# **Attachment A**

### **Loftus Street Upgrade**

#### **Summary of Changes and Additions to Initial Project Scope**

Drawing  
Loftus Street  
Preliminary Design - General Arrangements Plans

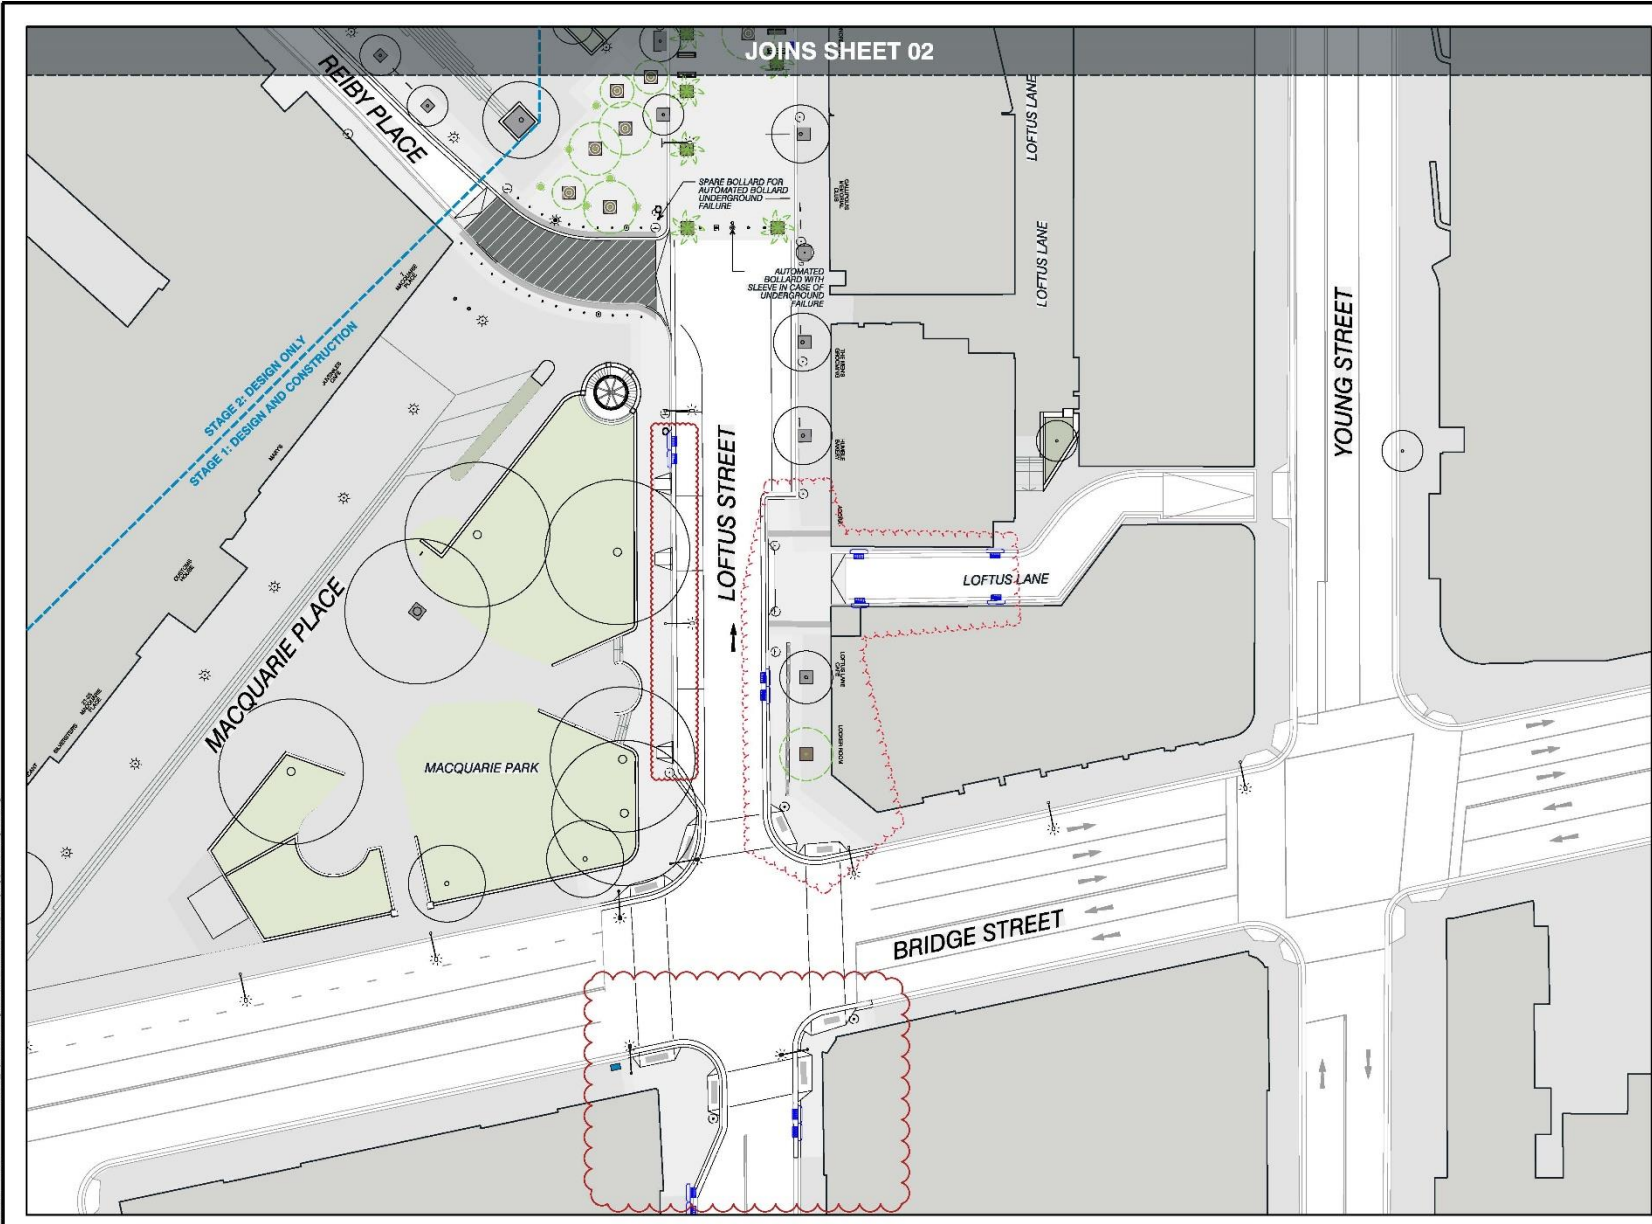
Change Item No.	Location	Change Summary	Additional Scope Required
1	Loftus Street and Alfred Street	Add to the existing avenue of street trees on Alfred Street and an additional row of shade/ canopy trees along Loftus Street.	Excavation for tree pits, including structural soil areas, utility service protection and tree planting.

<b>Change Item No.</b>	<b>Location</b>	<b>Change Summary</b>	<b>Additional Scope Required</b>
<b>2</b>	Customs House Lane	Introduction of a raised threshold in front of the entry to Customs House in line with Loftus Lane	Introduce a raised threshold on the road, footpath tie-in grading from Loftus Lane footpath to Custom House doorway, tactile ground surface indicators, utility service lid adjustments, and stormwater drainage infrastructure.
<b>3</b>	Customs House Lane	New inground lights	Additional pits, conduits and in-ground lights to enable feature lighting of the surface of Customs House Lane.
<b>4</b>	Loftus Street, north of Bridge Street	Existing footpath infrastructure at taxi ranks within the project site was identified as requiring upgrades to meet pending revisions to the Disability Standards for Accessible Public Transport.	Additional kerb ramps are to be constructed at the taxi rank.

<b>5</b>	Loftus Street and Loftus Lane	Construct continuous footpath treatment (CFT) to improve accessibility and pedestrian safety.	Amend road geometry, kerb and gutter, footpath pavement and grading, stormwater drainage infrastructure, bollards and tactile ground surface indicators.
<b>6</b>	Footpaths of Loftus St, north of Bridge St	In response to change item 6, the footpath gets extended, taking the opportunity of an existing no-stopping area in the road.	Four traffic lanes will be reduced to one lane in each direction at the signalised pedestrian crossing area. Footpath widening and street lighting will be amended to suit the new road geometry. Tree planting to fit the new footpath environment.

Change Item No.	Location	Change Summary	Additional Scope Required
7	South of the intersection of Loftus Street and Bridge St	The existing footpath does not adhere to equitable access requirements.	Reconstruct kerb ramps, amend traffic signal poles, lanterns and electrical assets; amend road geometry, signage and line marking, kerb and gutter alignment, footpath pavement and grading, street lighting and electrical infrastructure, and stormwater drainage infrastructure.
